Amendment #2 -- Briggs Avenue Extension

Durham-Chapel Hill-Carrboro Metropolitan Planning Organization

Comprehensive Transportation Plan
December 9, 2020

Amendment #2 – Delete Briggs Avenue Extension (December 9, 2020)

DCHC MPO Comprehensive Transportation Plan Amendment #2 -- Delete Briggs Avenue Extension

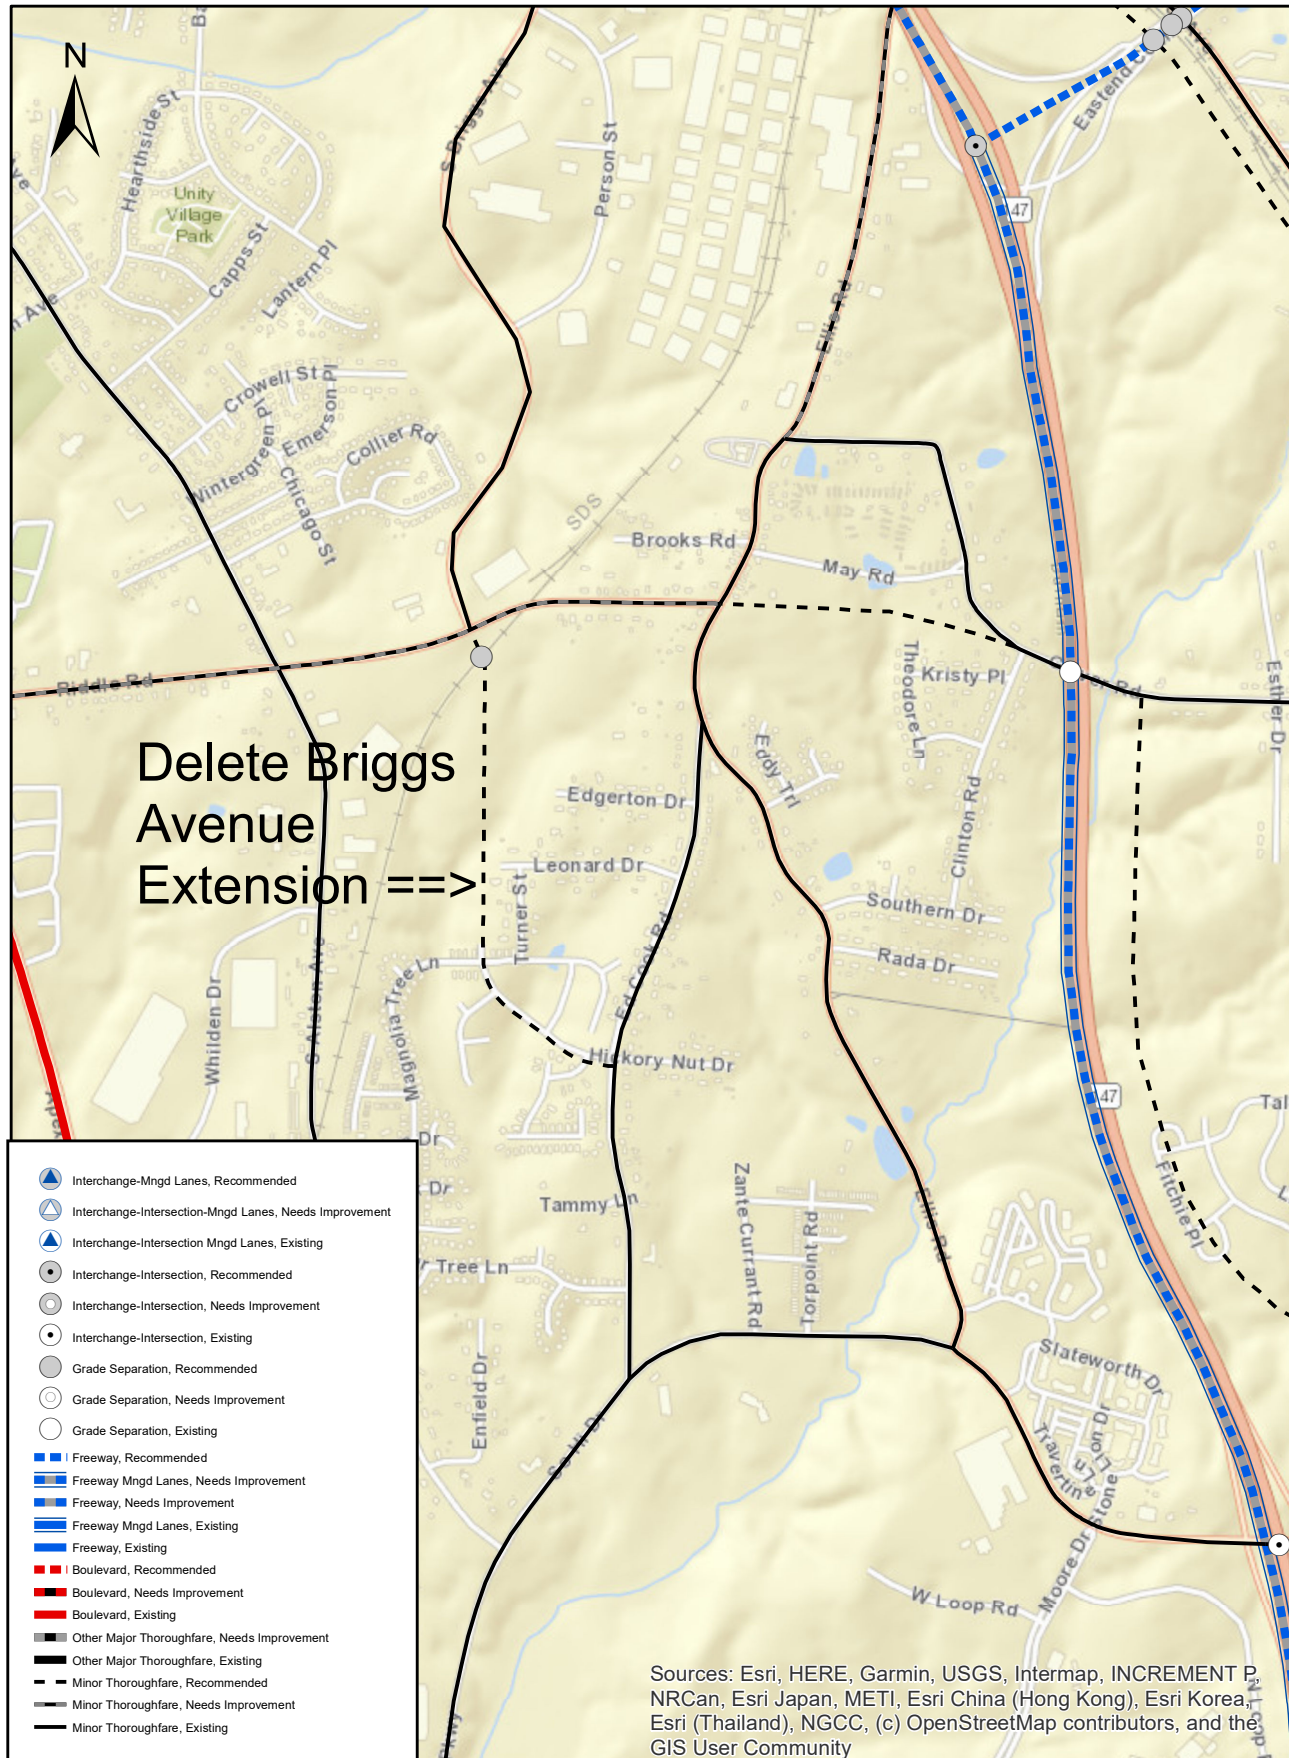
The Durham-Chapel Hill-Carrboro Metropolitan Planning Organization (DCHC MPO) hereby amends the Comprehensive Transportation Plan (CTP) to delete the proposed Briggs Avenue Extension from Riddle Road to Ed Cook Road. The CTP highway map on page 3 shows the roadway segment that is to be deleted.

Map -- The official CTP map deletes the Briggs Avenue Extension. See map on page 3
